Date: September 6, 2019

From: Julia M. Murphy, MS PG
Hydrogeologist/Professional Geologist

RE: OnSite Waste Treatment System, Circle A Subdivision

FIGURE 3
CIRCLE A - OWTS LOCATIONS
AND FOUNDATION SAMPLE LOCATIONS

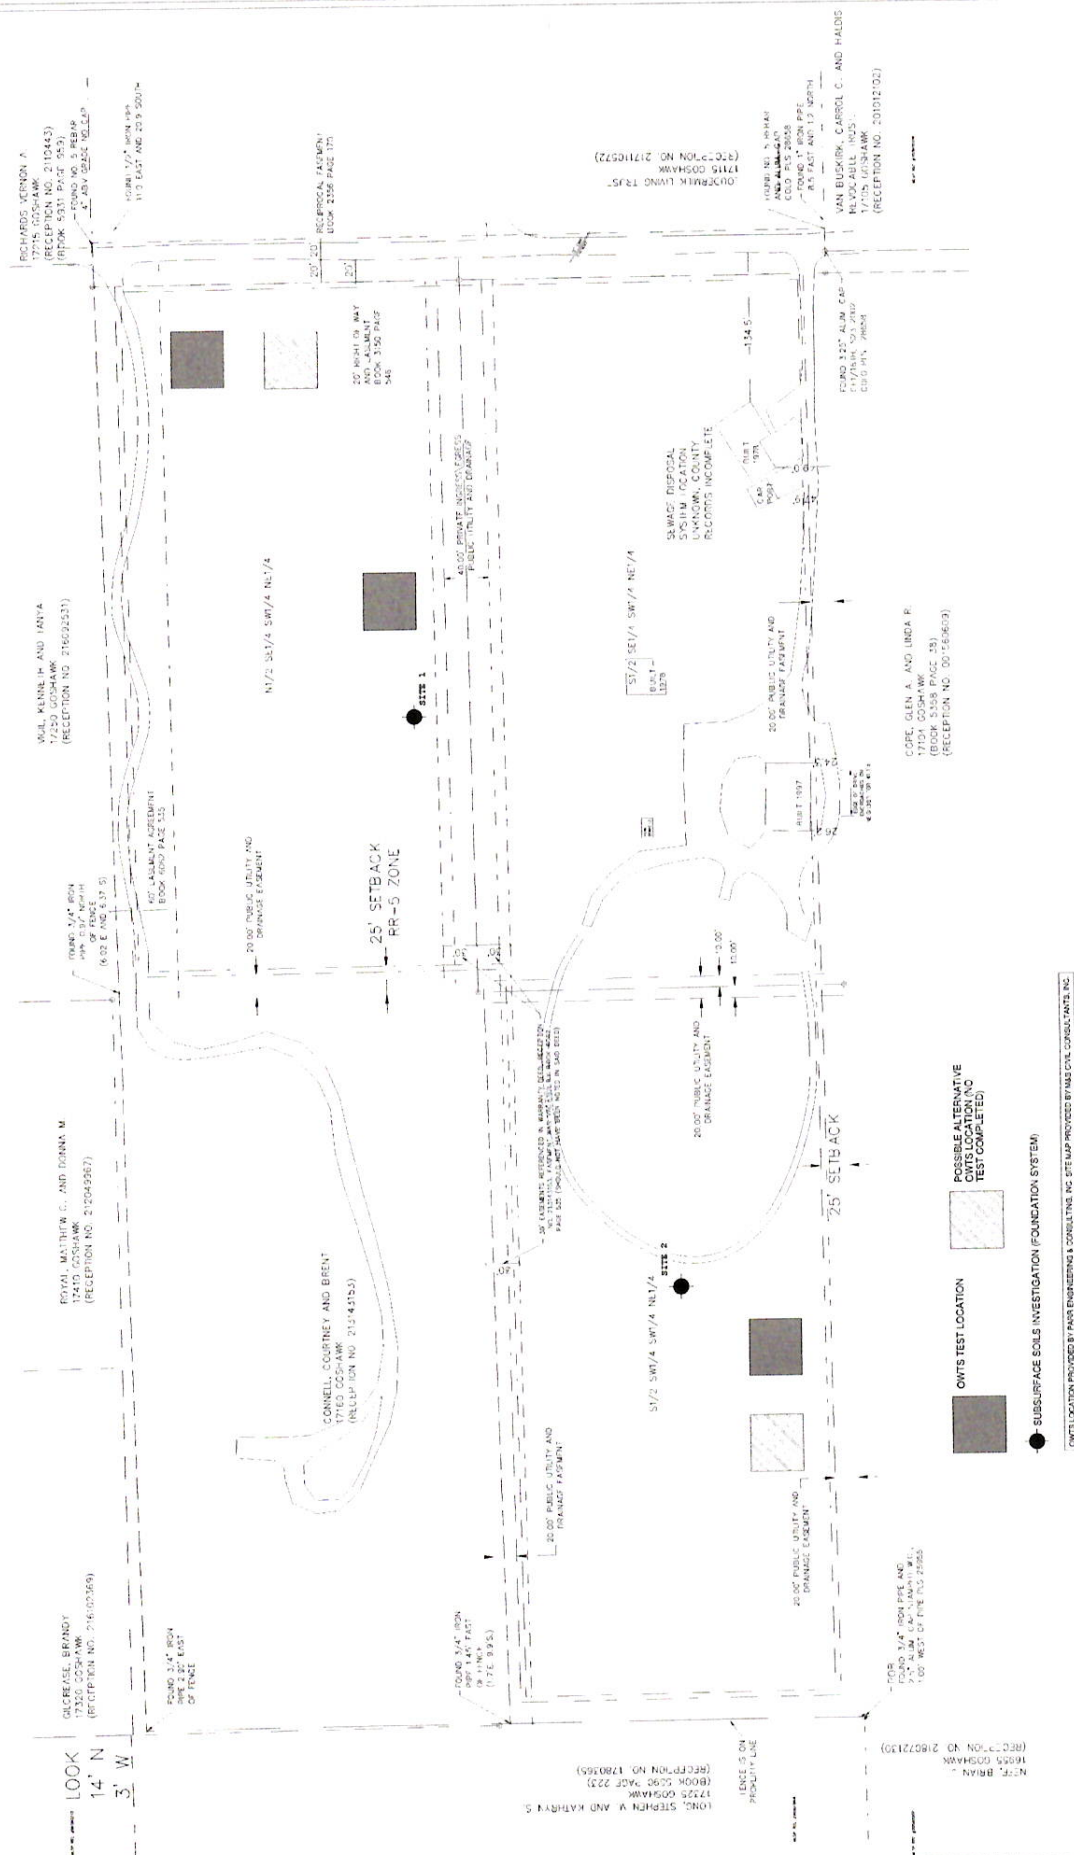
Please review LDC Sec. 8.4.8(C) and (E)(2)(d) and ensure that this report meets the requirements. Two sites appropriate for OWTS are required to be shown for ALL lots, including developed lot. You can show the existing, but you will also need to show an alternate location on the developed lot.

Any soils constraints will need to be depicted on the map as well.
